Re: Comprehensive Permit for Preliminary Plan Review – Village at Tiogue located at Tiogue Ave., and Tiffany Rd., Assessor’s Plat 32, Lots 149, 150, 151, and 153 (“Property”)

As you know, this office represents 232 Realty Associates, LLC (“Applicant”) in its Comprehensive Permit Application for the development known as the Village at Tiogue (“Project”). This correspondence is to provide contextual background of the Project’s travel and address additional feedback from the November Planning meeting on this Project.

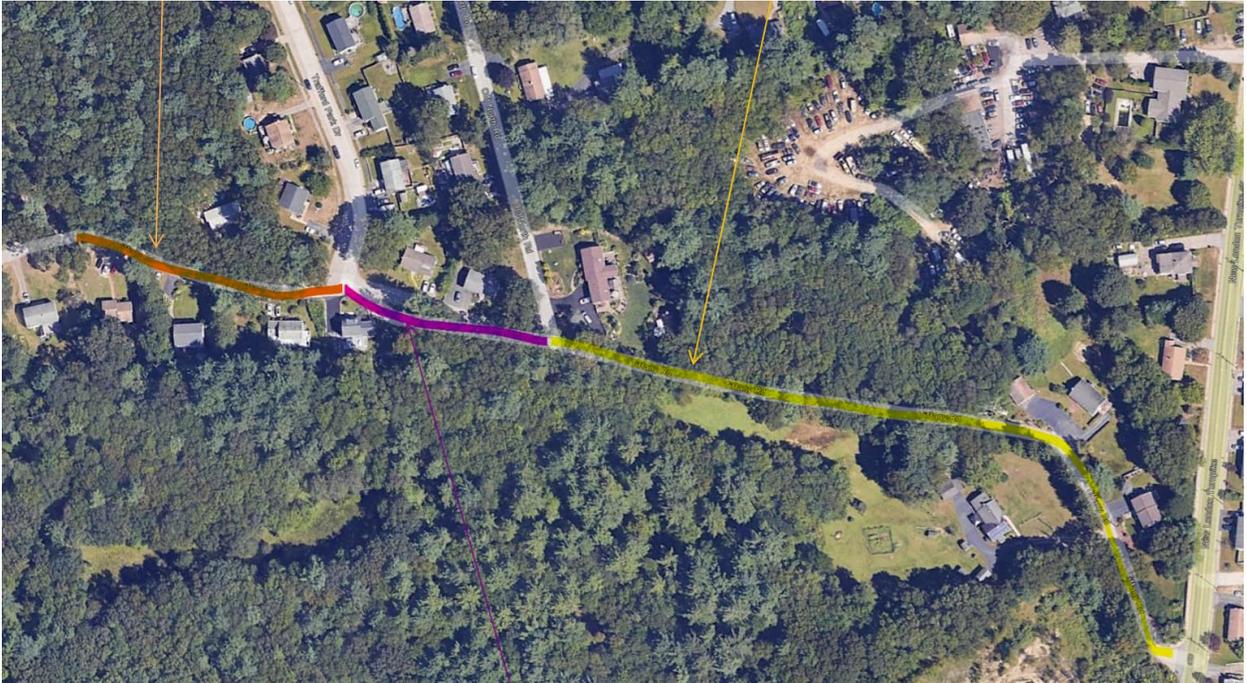
As set forth in our last correspondence, the area of Tiffany Road can be broken down into three portions.

Section 1 outlined in orange below, Section 2 outlined in pink below, and Section 3 outlined in yellow below:

Section 1, Western section of Tiffany Road from the site access road to Area 3, to Trafford Park Drive.

Section 2, section of Tiffany Road between Trafford Drive and Old North Road

Section 3, Old North Road to New London Avenue

This area of Tiffany is one-way westbound, with the width below 12' in areas and the pavement in poor condition. As noted in the Town's peer review report, the actual width of the right of way does not allow the roadway to be reconfigured for two-way traffic. After

The Plans are in agreement with the proposed mitigation in both expert reports whereby this area will be widened to 22 feet of pavement width with impacting vegetation cleared for safe passage.

The Plans reflect the applicant's agreement with the expert reports that that this area be widened to 22 feet and impacting vegetation cleared, similar to Area 1.

The revised plans commit to the widening of Tiffany Road in this section to 12 feet to ensure safe one-way passage in accordance with fire code standards, the repaving of the asphalt and the clearing of select vegetation.
